Re: WT Docket No. 01-309
Section 68.4(a) of the Commission's Rules Governing Hearing Aid
Compatible Telephones

**ATIS Industry Solutions Program #4 –
Hearing Aid Compatibility
(AISP.4-HAC)**

**Comments in Response to
TCB Training Slides**

Issue - Slide 32, Vocoder modes

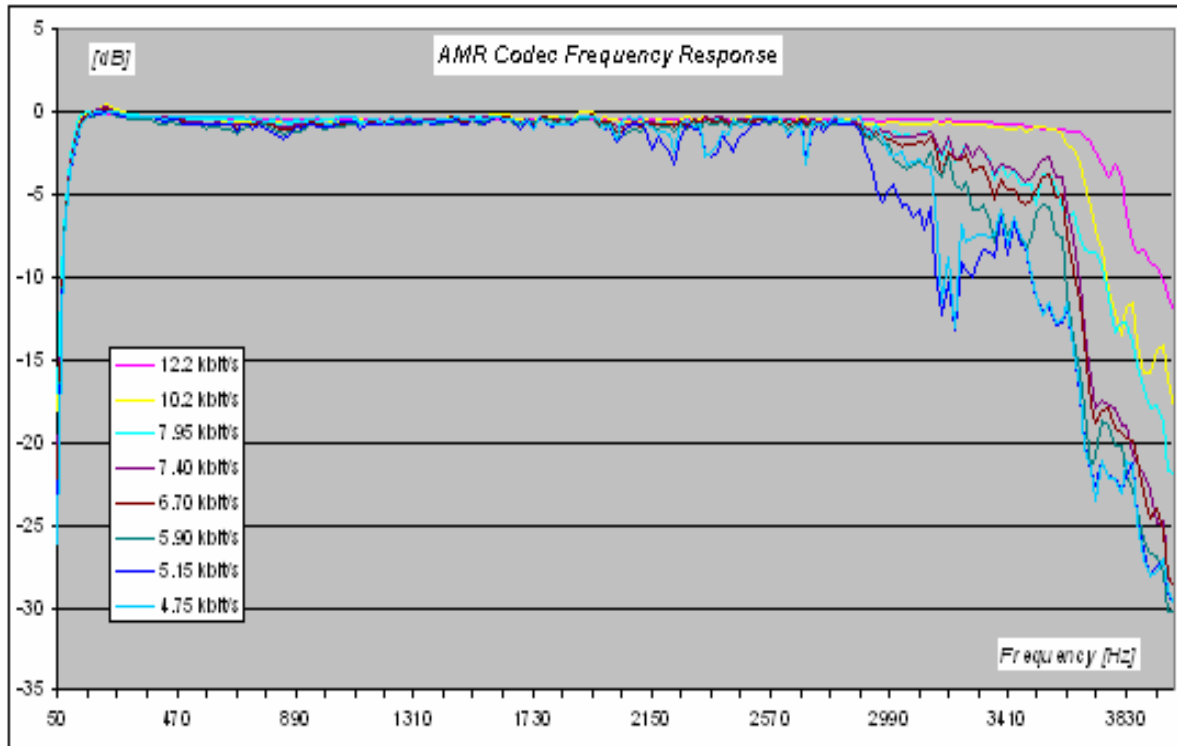
WG-4 Rationale - Slide 32, Vocoder Modes

- Most vocoder modes will not pass HAC T-Coil frequency response requirements.
- Many vocoders are not intelligible (used to hold a call up during periods of silence, conserving bandwidth). An example is CDMA 1/8 rate.
- GSM, iDEN, and UMTS vocoder rates have no impact on HA interference. GSM (EFR), utilizes best speech quality
- Vocoder voice quality degradation is the same for all. HAC devices should meet same requirement.

WG-4 Rationale - Slide 32, Vocoder Modes

- Significant time is added to test time when requiring all vocoders.
- AISP.4-HAC Agreement
 - **“When performing C63.19 sections 6.3 & 6.4, the same vocoder rate that is used in section 4.4.1.2.2. should be used during the measurement.”**

WG-4 Recommendation - Slide 32, Vocoder Modes

- Adopt the AISP.4-HAC agreement reached regarding evaluation and testing vocoder modes for hearing aid compatibility.
